## **ADDENDUM #4**

### **Rye City School District**

#### **Osborn Elementary School**

#### **Midland Elementary School**

SEAL & SIGNATURE | DATE: 07/27/20  
PROJECT No: 9200  
DRAWING BY: Author  
CHK BY: Checker  
DWG No: A3-601

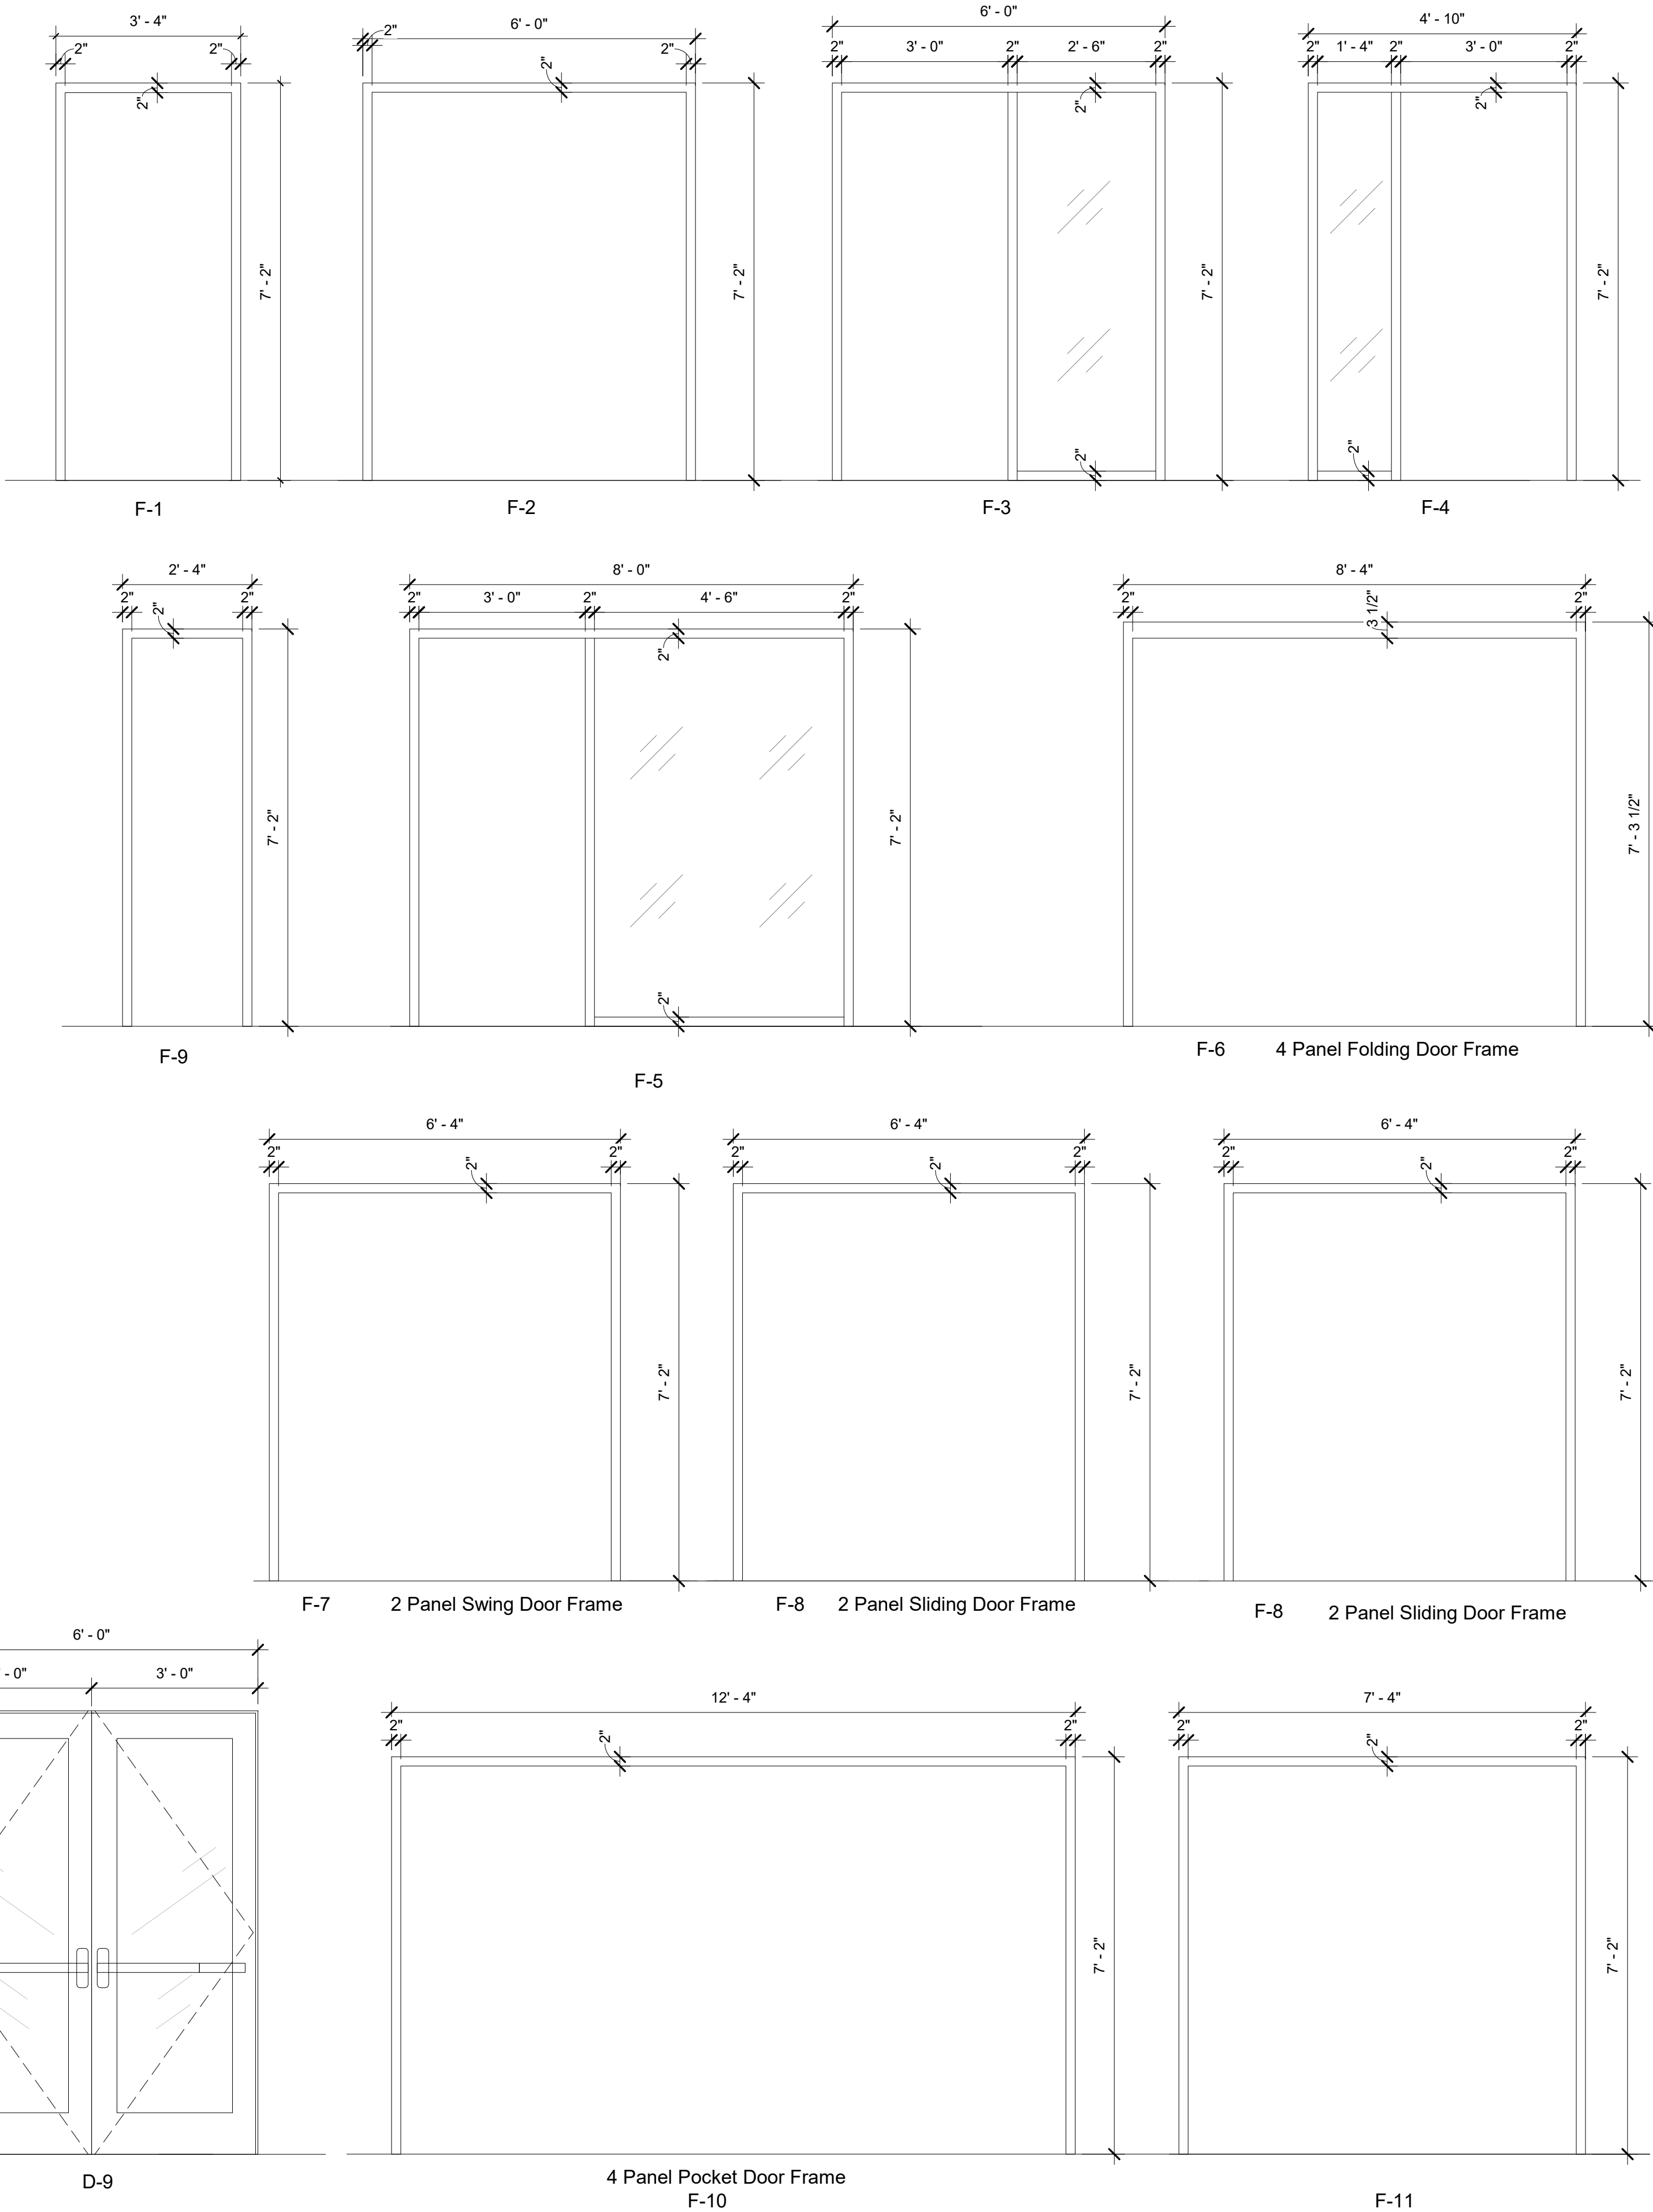
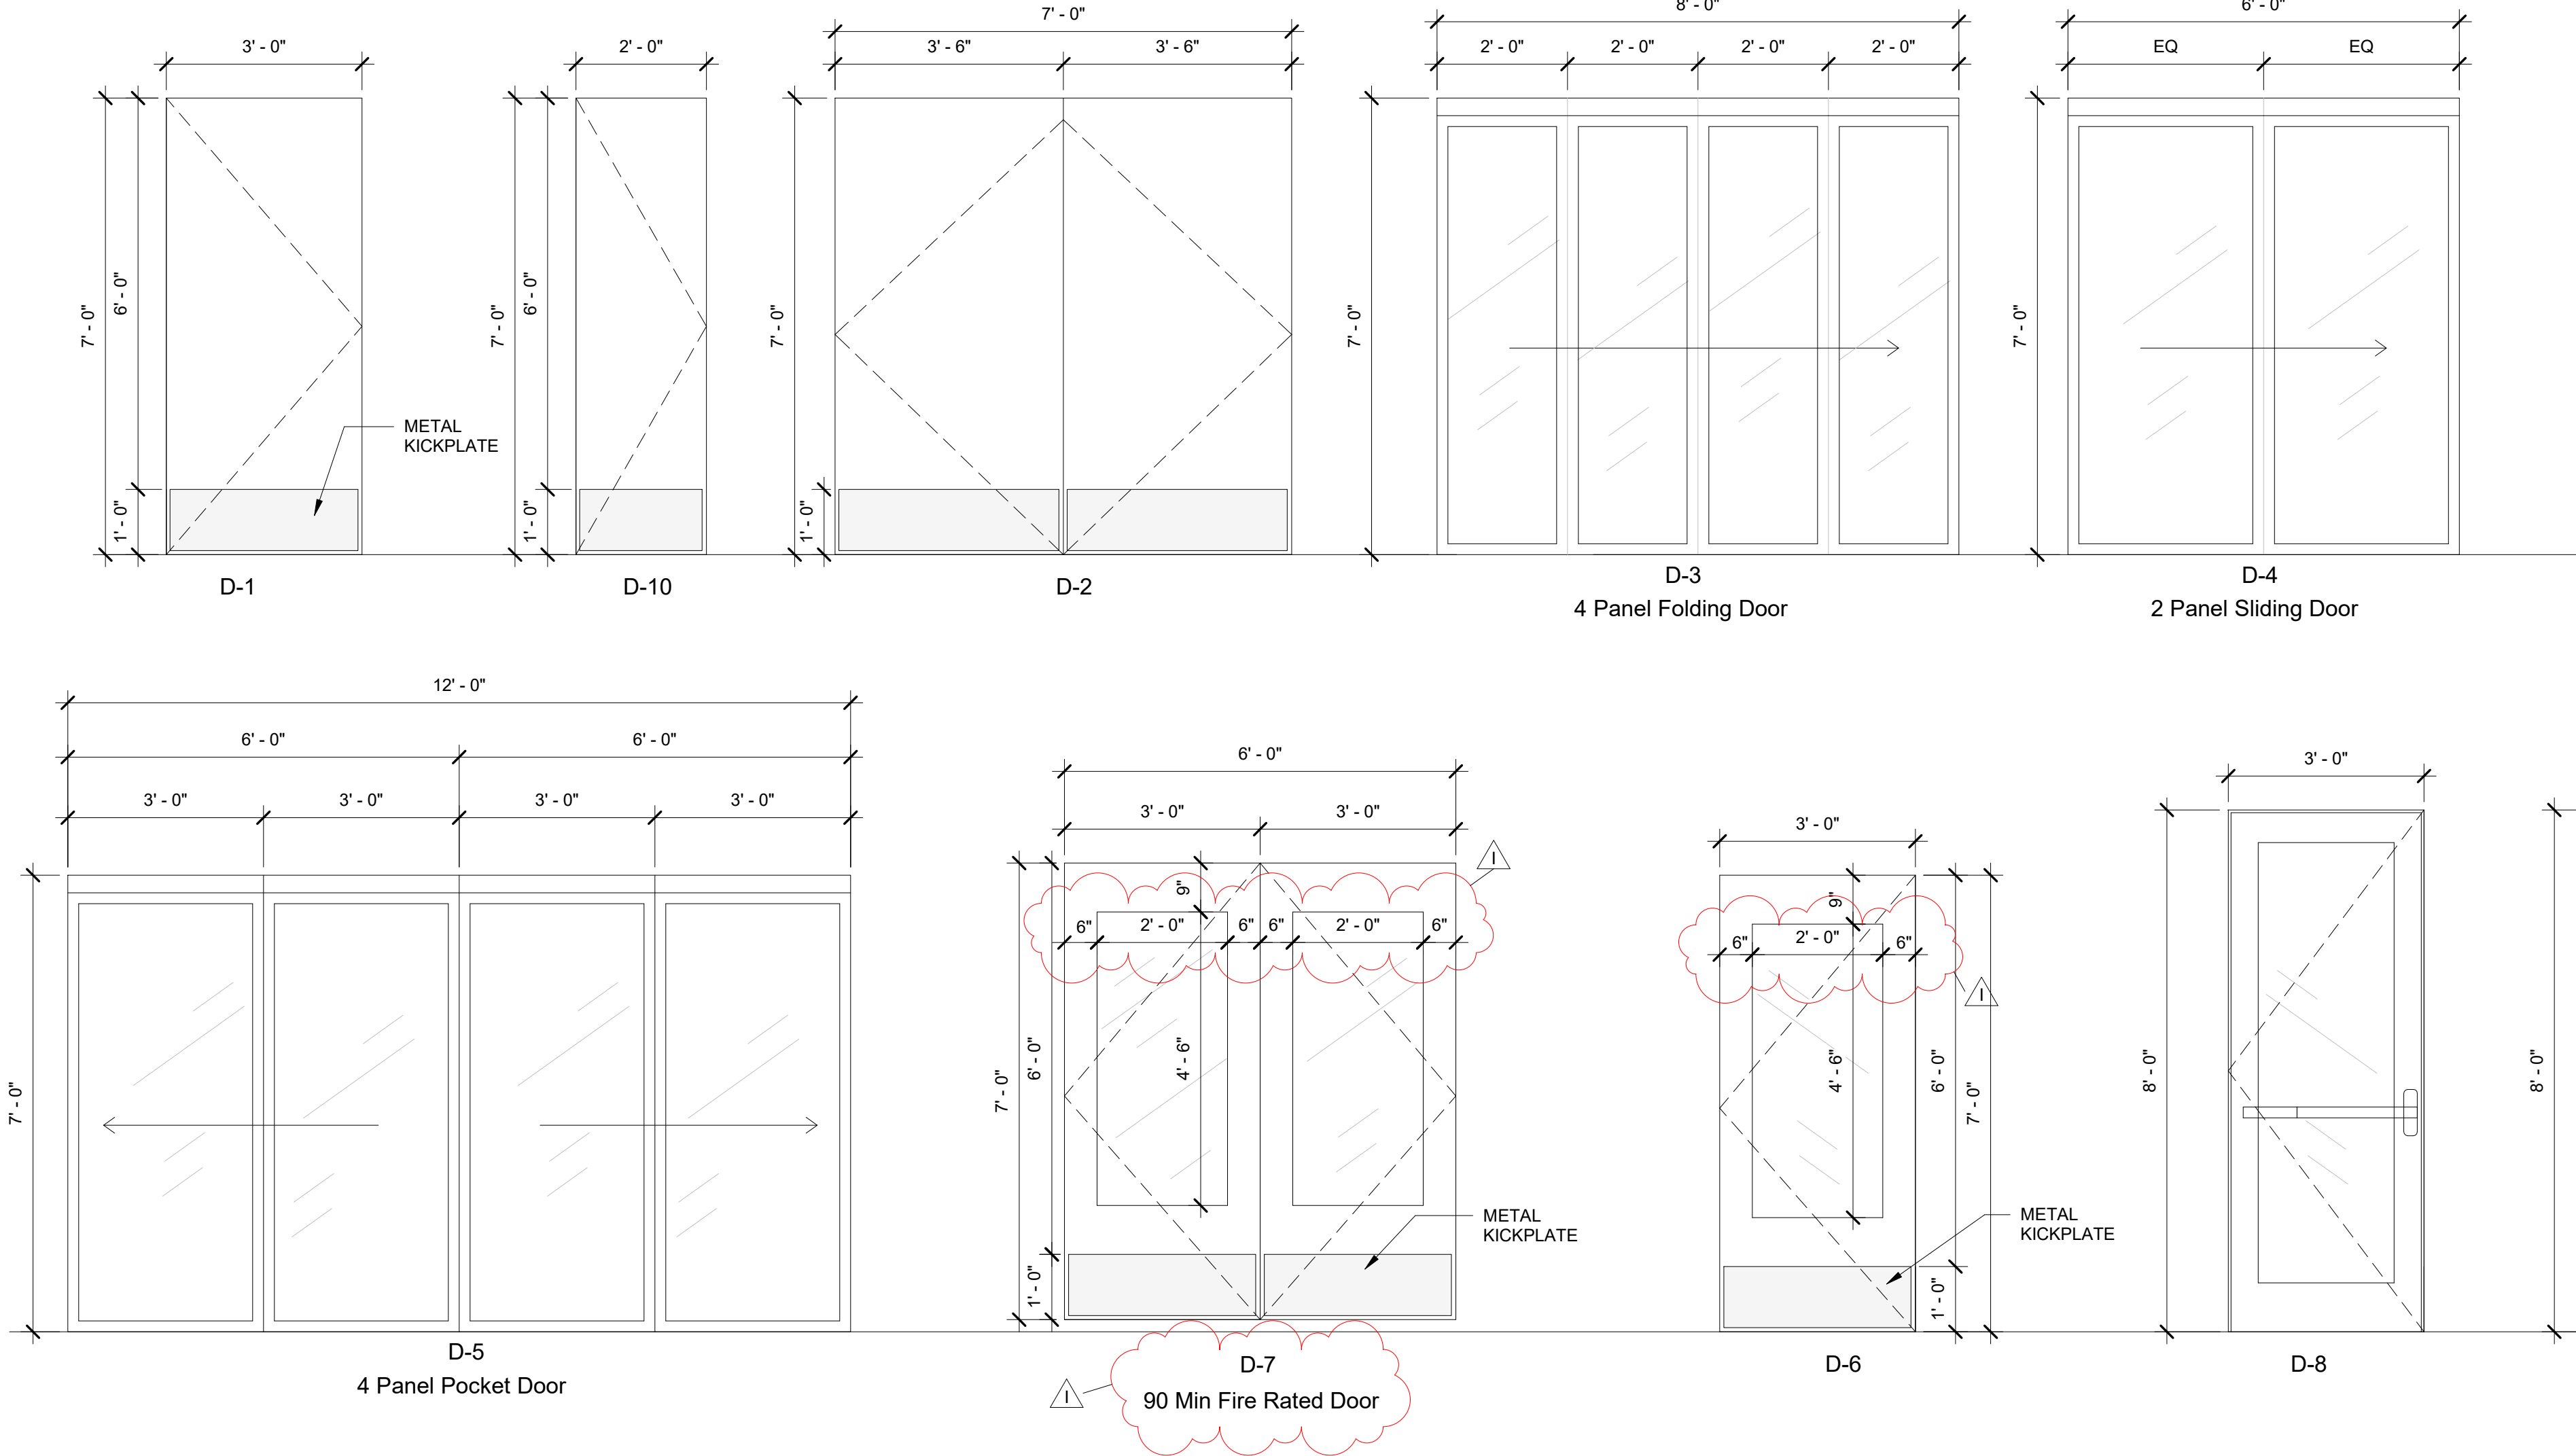
- a. Door types and dimensions adjusted to correspond to allowable glazing size for fire-rated doors. Door types D-3A and D-3B added.
  - b. Hardware groups added for doors where this information was previously missing

- c. Door material clarified for exterior doors to be aluminum/glass
  - d. Glazing Type legend added to sheet
  - e. Glazing type column added to door schedule

spec calls for GPX Framing System & 90 min glass. The GPX System is a fire rated aluminum framing system typically used on doors which have multiple sidelites, not stand alone doors. The door schedules for osborn & midland only show a few doors with glass at each school to be fire rated (45 min &/or 90 min) however those particular tags are shown to be wood doors with hm frames - which is not offered by Safti-First. In the event that spec section 088813 does not apply to those door tags and they are in fact to be fire rated wood & hm doors with glass - we have been informed by door suppliers that they cannot maintain a 45 min or 90 min rating with 4'-6 x 2'1" vision lites as it is too large. Please Advise.

**Answer:** spec section 088813 does not refer to the doors mentioned above, and will be removed from the set. Door panel materials are to be per door schedule. Updated drawings and specs will be provided in Addendum #4: Door types have been updated to reduce glazing size spec section 081400 Wood Doors updated to include Fire-rated doors.

SEAL & SIGNATURE | DATE: 09/11/20  
PROJECT No: 9200  
DRAWING BY: Author  
CHK BY: Checker  
DWG No: A3-602

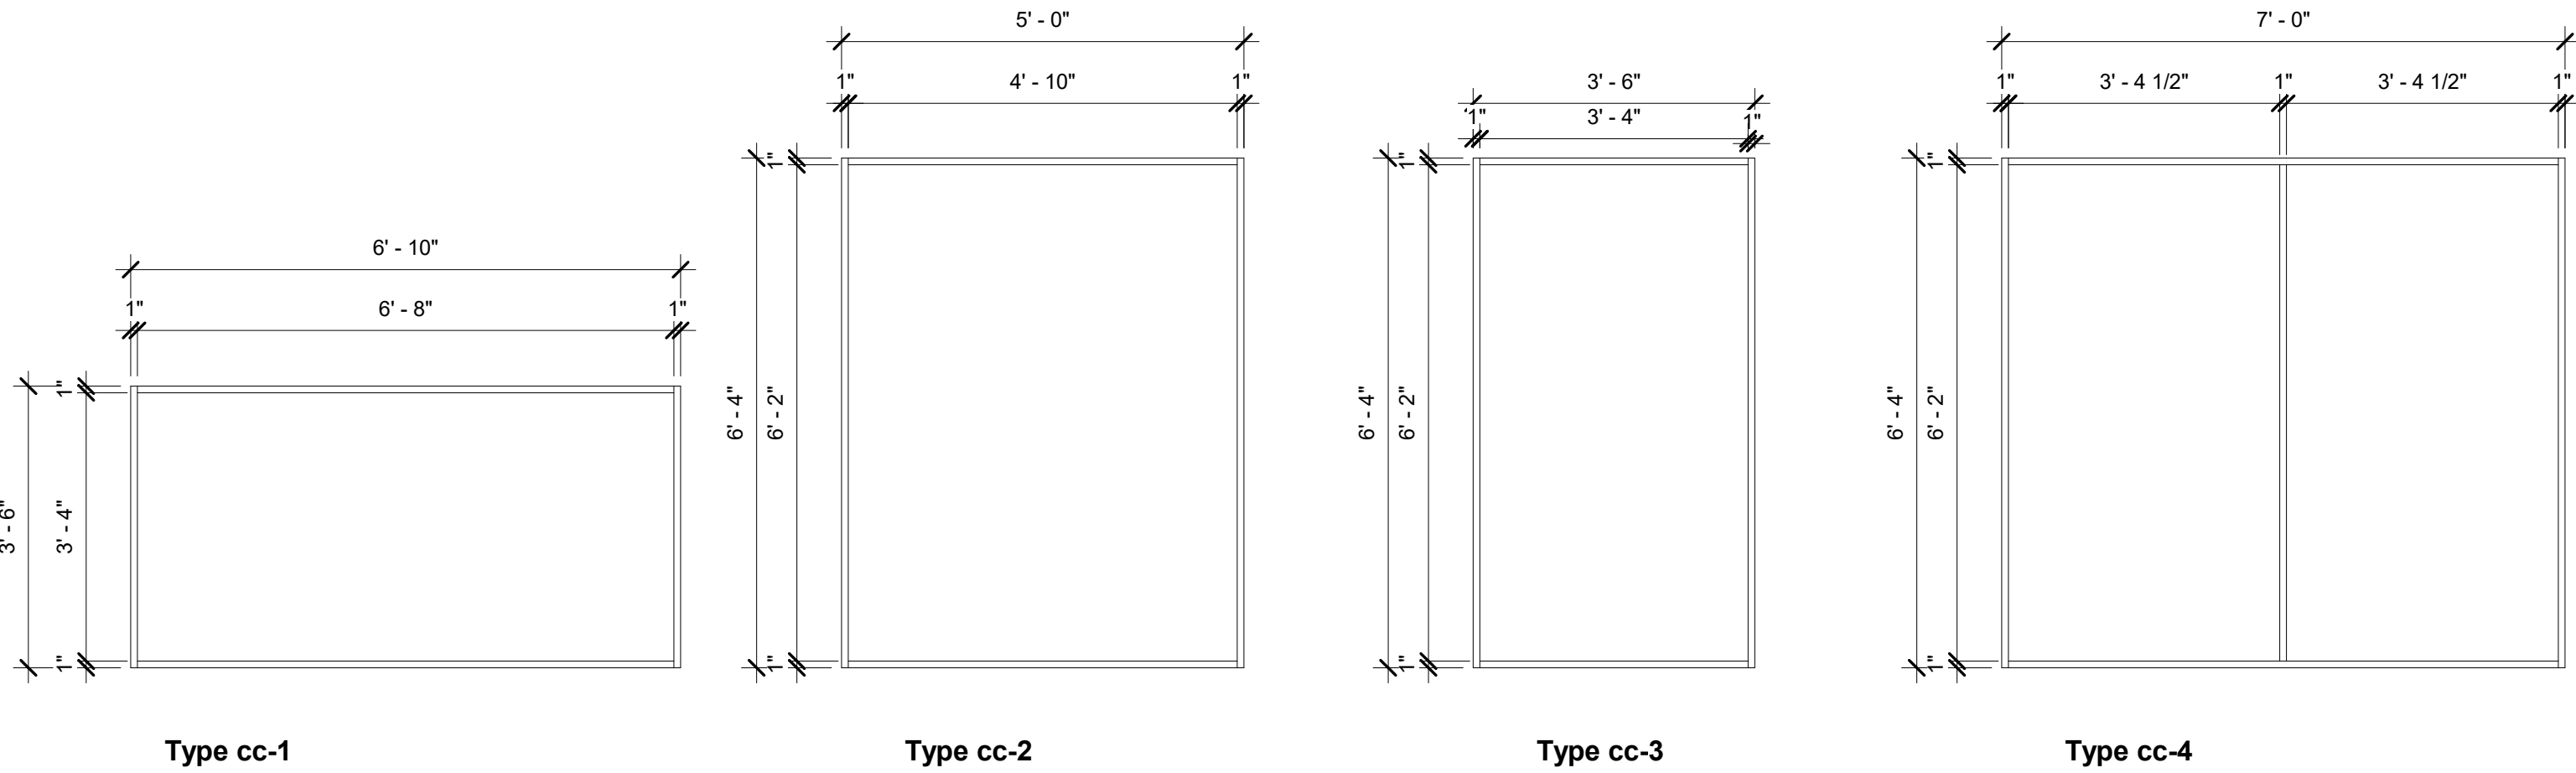
3. A3-602 – INTERIOR WINDOW TYPE AND SCHEDULE
  - a. Glazing type column added to interior glazing schedule
  - b. Glazing Type legend added to sheet
4. A3-603 – EXTERIOR WINDOW TYPE AND SCHEDULE

**Answer:** These windows do not need to be fire-rated. Updated schedule provided in Addendum #4.
6. **Question:** Please provide glazing schedule on the architectural drawing associating the different glass products found in section 088000 with aluminum/HM/wood doors frames and windows.

**Answer:** Door and window schedules updated to show glazing type per specifications.
7. **Question:** Please clarify which door tags spec section 088813 applies to. The
